Assessment Officer Report

17 Slalom Street, Falls Creek
PA2403149

Officer Assessment Report
Development Approvals & Design

Figure 3: Existing and proposed Level 2 – Source: Application

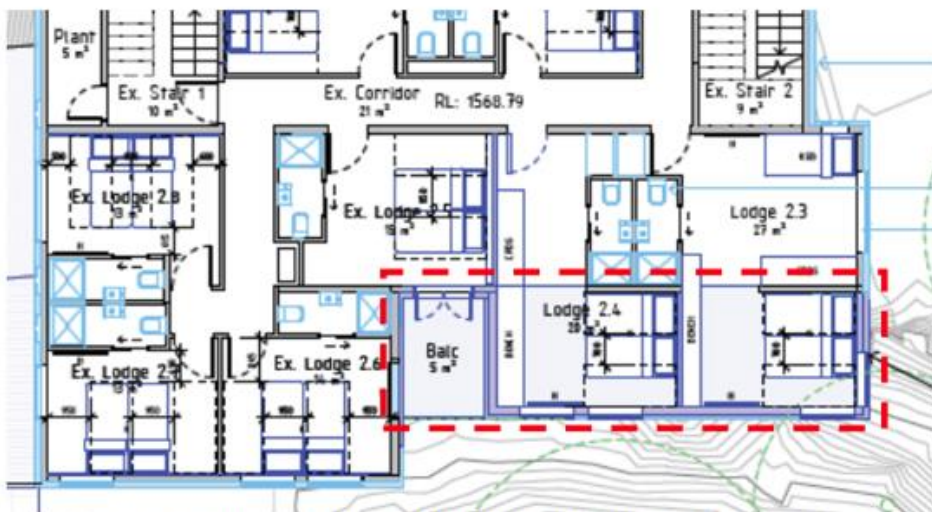
56. The most significant change to the proposal is the extension of the building at Levels 2 and 3 towards the south. At Level 2, the building will be extended out to increase the size of Lodges 2.3, 2.4 and 2.5. The changes to Lodges 2.3 and 2.4 will create an additional bedroom, while the change to Lodge 2.5 will create a small 5sqm balcony. The proposed changes to Level 2 will create a minimum 4.46m setback to the Arlberg Street lease boundary. The existing setback to Arlberg Street lease boundary is 4.53m. While the DDO2-A1 specifies a 6m setback to a road frontage, the change from the existing minimum setback to this lease boundary is marginal at 0.07m. As such, this is considered reasonable given there is a wide road reserve area between the lease boundary and the road pavement at Arlberg Street.

Figure 4: Existing and proposed level 3 – Source: Application

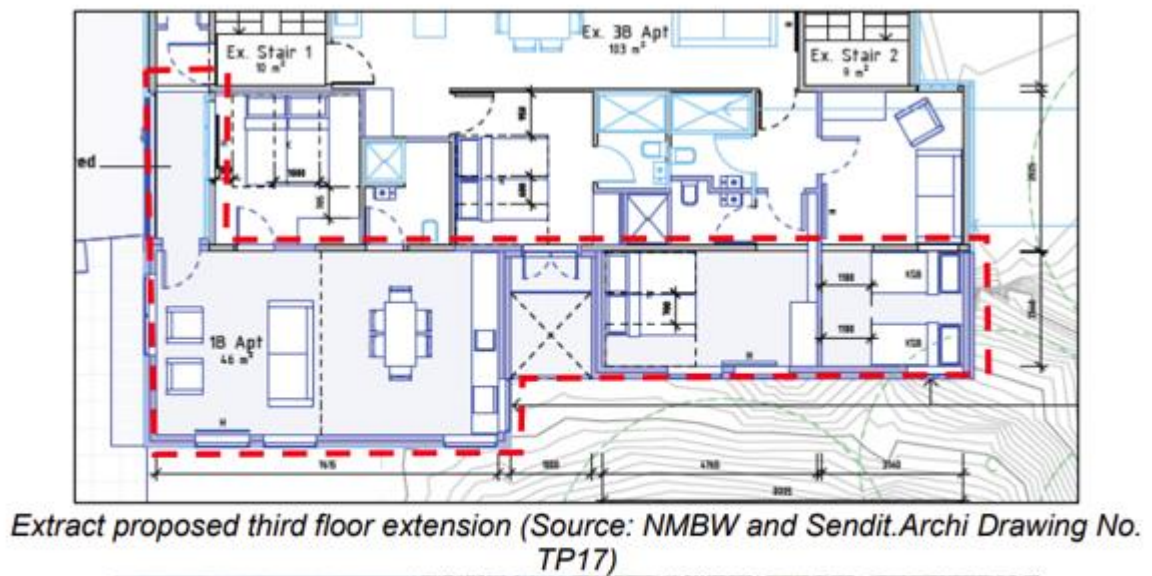
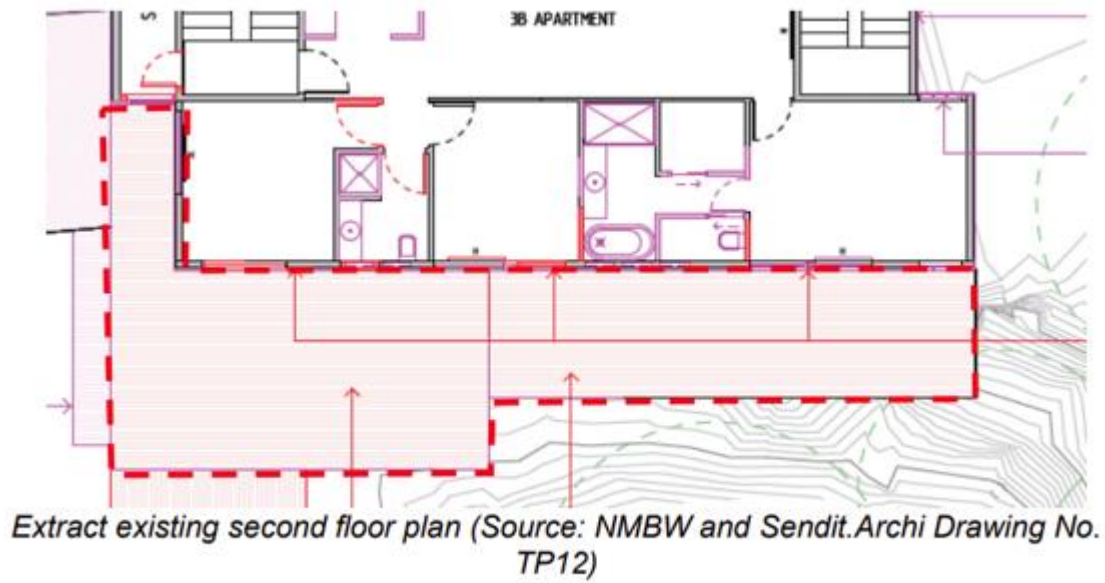
57. Similarly, the changes to Level 3 to alter the layout of 3B Apartment and extend it towards the south and the creation of a new one bedroom dwelling, creating 1B Apartment, are similar to those at Level 2. The existing minimum setback at Level 3 is 4.53m. The proposed additions to Level 3 will reduce the setback to the Arlberg Street lease boundary by 0.07m. As such, the minor setback change is considered reasonable as it will be in line with the

proposed changes at Level 2 below. Furthermore, the building incorporates a built form that is varied and articulated and thus any bulk and mass from the Levels 2 and 3 additions is not unreasonable.

62. It was outlined earlier that while an additional dwelling is being created on Level 3, Clause 58 Apartment developments does not technically apply. However, whether the new dwelling achieves appropriate amenity, design and layout should be considered.

63. The internal amenity of the new dwelling includes one bedroom which meets the minimum bedroom dimension requirements. Furthermore, the living area comprises approximately 28sqm and has a minimum width of 4m, exceeding the minimum living area dimensions specified in the relevant standard which is 3.3m.

64. The layout, design and layout of the new dwelling includes a large living area that easily exceeds the 10sqm standard D26 minimum living area of Clause 58. The living area includes one west facing window and three south facing windows. It should be noted that while the living room windows face south and west, the size of the lounge area and the windows are large and therefore will achieve reasonable natural light.

Figure 5: 3 exotic trees to be removed – Source: Application (modified to include mark-ups)

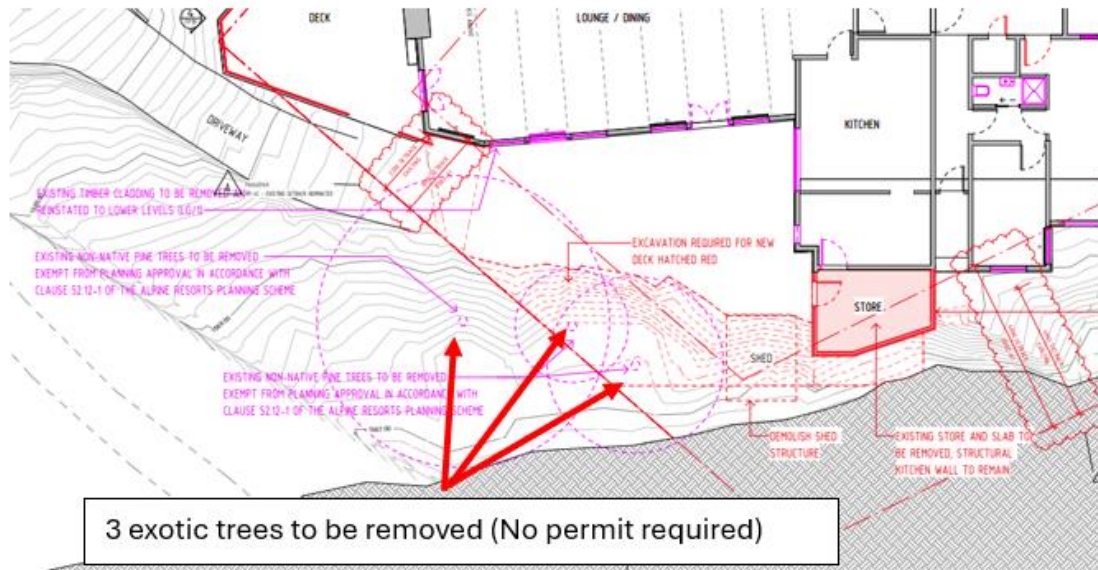
- 
26. The proposed development includes the removal of 3 exotic (pine) trees, located to the south/west side of the site. A permit is not required to remove the 3 trees as they are exempt pursuant to Clause 52.12-1 of the Scheme. The trees in question are located within 10m of an existing building used for accommodation which was constructed before 10 September 2009.

Figure 6 – Sections, showing proposed development in blue outline – (Source: Application)

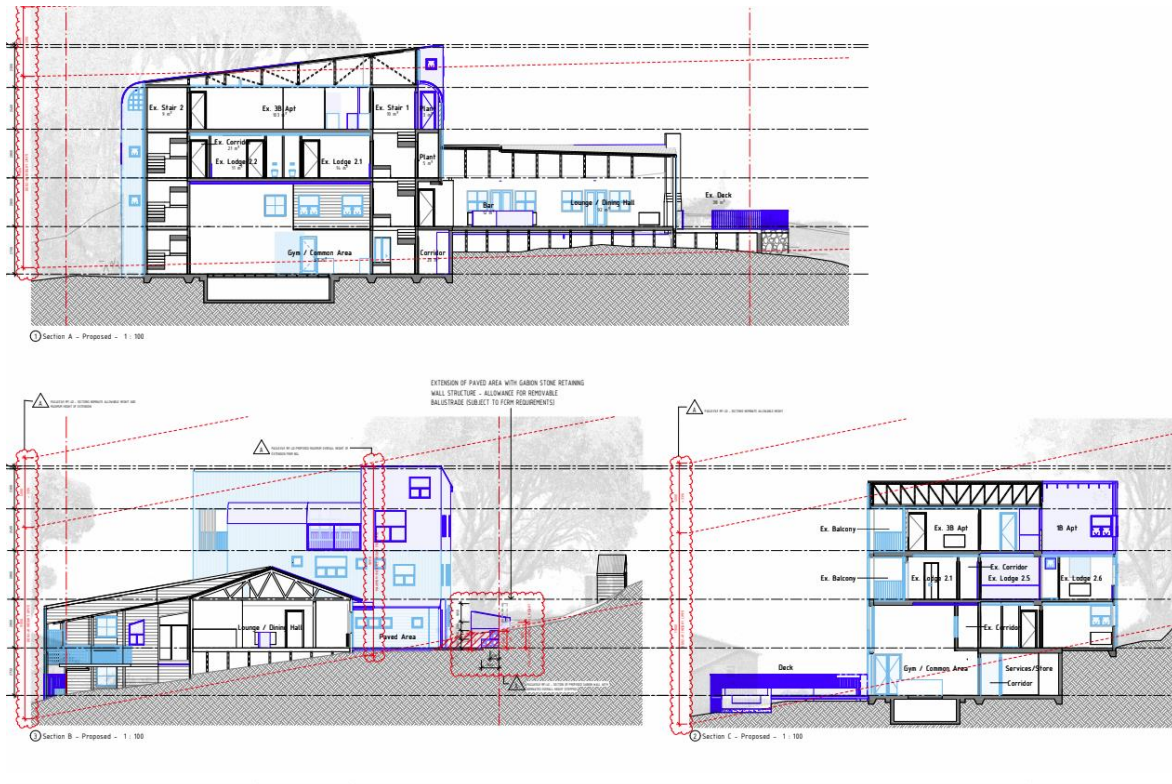
58. In terms of maximum height, it should be noted that the existing building already exceeds the 11m height specified in the DDO2-A1, as part of the building reaches an existing height of 13m. However, the area where Level 2 and 3 will be extended will achieve a maximum building height from natural ground level of 10.91m. This is shown in Section B of the architectural plans (specifically TP22).

59. While the proposed alterations and additions at Levels 2 and 3 will add some volume to the building, it will be without a substantial increase in building height at this area. The crossfall from west to east and south to north allows the building height of the additions to be kept under 11m. As such, the proposed additions to this area are considered reasonable.
